1 **DRAFT**
2 **WISCONSIN DEPARTMENT OF AGRICULTURE, TRADE, AND CONSUMER PROTECTION**
3 **TECHNICAL STANDARD**
4 **VERIFICATION OF DEPTH TO BEDROCK**
5 **01**

6
7 **BROAD REVIEW COMMENTS AND RESPONSES**

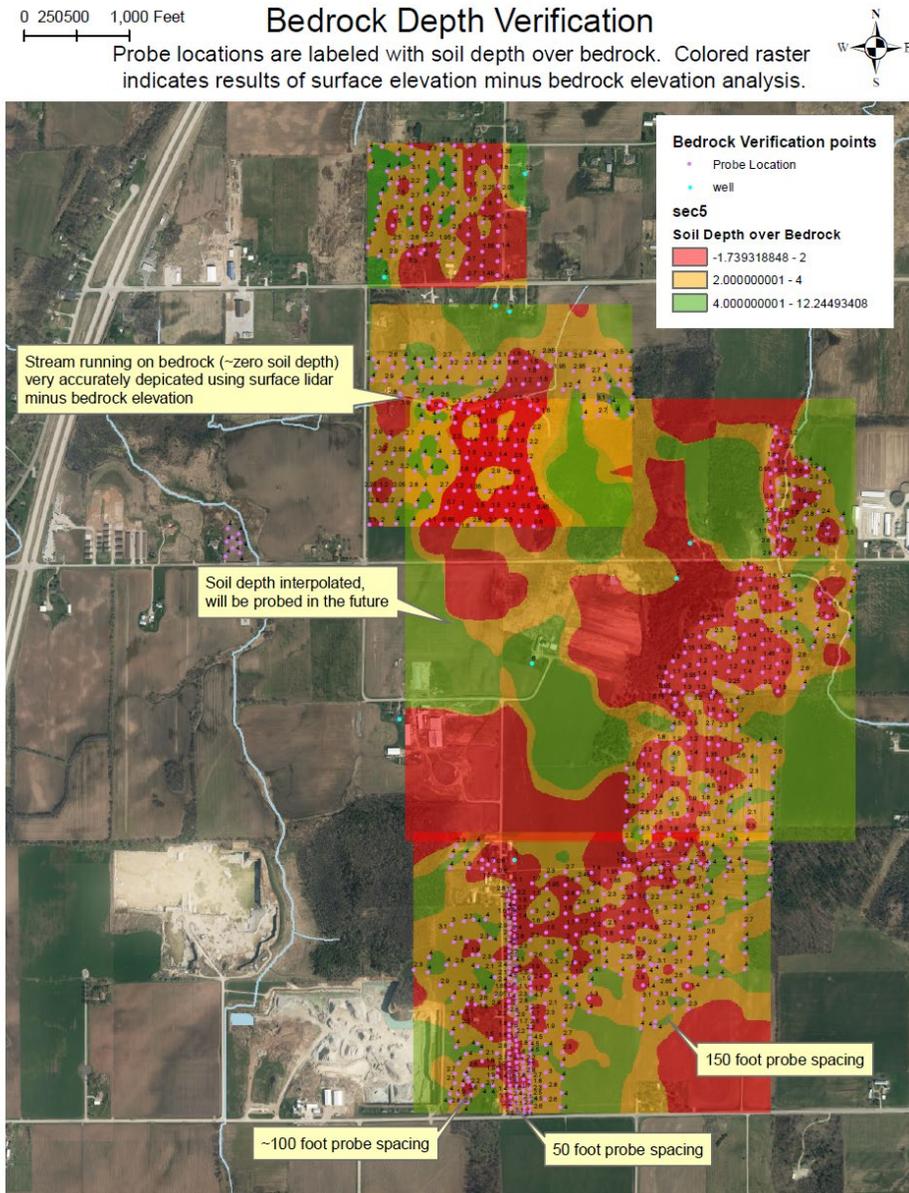
381 **C19:** We tested 50 ft (~1/20 acre), 100
 382 ft (~1/4 acre), and 150 ft (~1/2 acre)
 383 probe spacings. The attached map
 384 [pasted below] shows areas of varying
 385 probe densities on the finished bedrock map.
 386 In this case the final map changed
 387 very little at three different sample
 388 densities. While additional probing may
 389 be necessary to delineate a definitive
 390 area of less than 24 inches of soil over
 391 bedrock, areas like we tested where a
 392 very large area is 20-36" to bedrock we
 393 found a probe density of 150 ft was
 394 adequate to make an accurate map of
 395 soil depths.

396 **RESPONSE:** Thanks for the
 397 time spent on this example. The
 398 team spent a lot of time
 399 discussing the spacing,
 400 considering accuracy and cost.
 401 We created some test sampling
 402 plans using real data to see how
 403 verification and boundary lines
 404 would change with different
 405 densities and also compared
 406 actual intrusive and geophysical
 407 data to compare the accuracies
 408 of different methods and
 409 densities. After much team
 410 discussion and review of in-field
 411 examples, the team decided that
 412 the 1/4 acre spacing would give
 413 us a reasonably accurate
 414 depiction of the variation of the
 415 depth to bedrock in a field while
 416 also remaining cost-effective.
